To: **Plan holders for Aberdeen Park Pickleball and Tennis Court Renovation – Belvidere Park District**
via Email ONLY

Re: **Addendum #1 - Aberdeen Park Pickleball and Tennis Court Renovation**

C-04 DETAILS

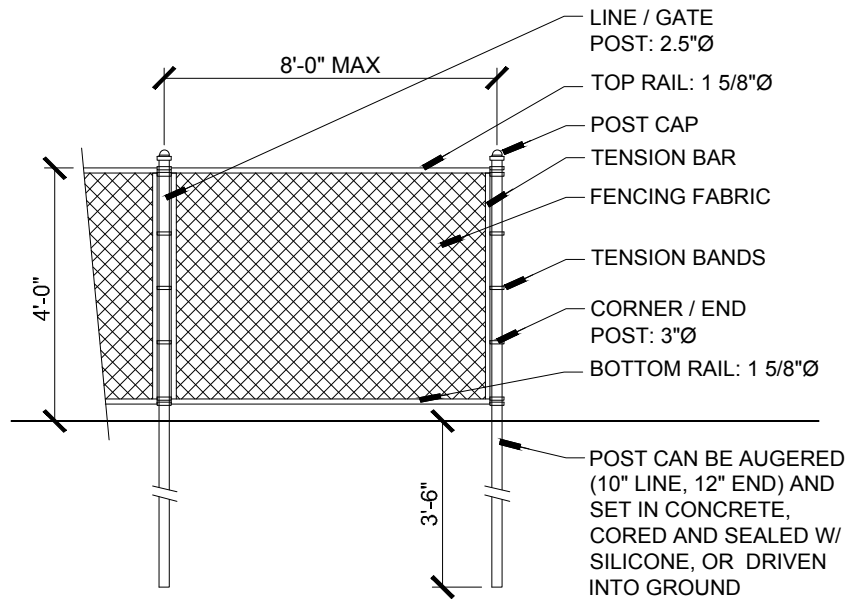
5. 4' HIGH CHAIN LINK FENCE DETAIL:
The line/gate posts are to be 2.5" OD; the corner/end posts are to be 3" OD; Posts are to be 3'-6" (42") depth and can either be augured (10" line/gate, 12" end/corner) and set in concrete, cored and sealed with silicone, or driven into the ground depending on the location or application.
6. 10' HIGH CHAIN LINK FENCE DETAIL:
The line/gate posts are to be 2.5" OD; the corner/end posts are to be 3" OD; Posts are to be 5'-0" (60") depth and can either be augured (10" line/gate, 12" end/corner) and set in concrete, cored and sealed with silicone, or driven into the ground depending on the location or application.
